BEFORE THE BOARD OF PATENT APPEALS
AND INTERFERENCES

Appeal 2007-4432
Application 09/980,430
Technology Center 2600

DECISION ON APPEAL

Appellants invented a coil assembly for an electro-acoustic transducer. The assembly includes a coil having an opening defining a longitudinal axis and an electronic circuit board positioned against and adhered to the coil in essentially perpendicular relationship to the axis. The circuit board may include electronics for signal processing. This assembly reduces the labor and time involved in constructing the transducer.²

Figure 57 of the ARRL Handbook (Page 31-25) is reproduced below:

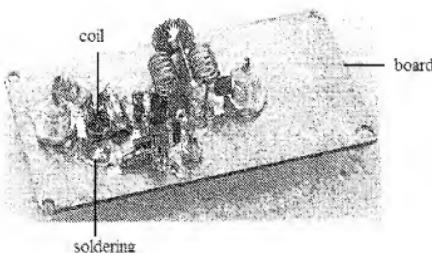
As shown above, the ARRL Handbook discloses a coil assembly comprising a coil (see coil reference line) having a coil opening defining an axis therethrough and an electric circuit board (see board reference line) wherein at least a surface portion is positioned against the coil in a substantially perpendicular relationship to the axis (The ARRL Handbook, 25; Fig. 57). While Figure 57 does not state the board is an electric circuit board, the plate clearly functions as part of the circuit to connect the electrical components shown into an integrated preamplifier. Thus, giving the term, "electric circuit board," its broadest reasonable interpretation, the board shown in Figure 57 is an electric circuit board.

Additionally, we note that Figure 57 shows a preamplifier, and claim 8 recites “a coil assembly for an electroacoustic transducer.” The phrase, “for an electroacoustic transducer,” is language relating to the function or intended use of the coil assembly. As courts have stated, “the absence of a disclosure relating to function does not defeat the Board’s finding of anticipation. It is well settled that the recitation of a new intended use for an old product does not make a claim to that old product patentable.” *In re Schreiber*, 128 F.3d 1473, 1477 (Fed. Cir. 1997). Thus, while Figure 57 and its description do not disclose the coil assembly being used in an electro-acoustic transducer, the disclosed assembly of Figure 57 is nonetheless capable of functioning as a coil assembly for an electro-acoustic transducer if it were so employed. Moreover, the coil assembly in Figure 57, as discussed above, includes all the recited structural limitations of claim 8. We, therefore, find that the coil assembly in Figure 57 of the ARRL Handbook anticipates claim 8.

Regarding claims 27 and 35, Figure 57 shows a surface portion of the electric circuit board is positioned against the coil by adhesion or soldering (see soldering reference line).

Regarding claims 29 and 31, both include the additional limitation of the electric circuit board having electronics for signal processing. As the device in Figure 57 is a preamplifier, there are ample electrical components that perform signal processing, including an output filter (the ARRL Handbook, 26). Thus, Figure 57 of the ARRL Handbook meets the limitations of the “electric circuit board includes electronics for signal processing” recited in claim 29 and the “electric circuit board including signal processing electronics” recited in claim 31.
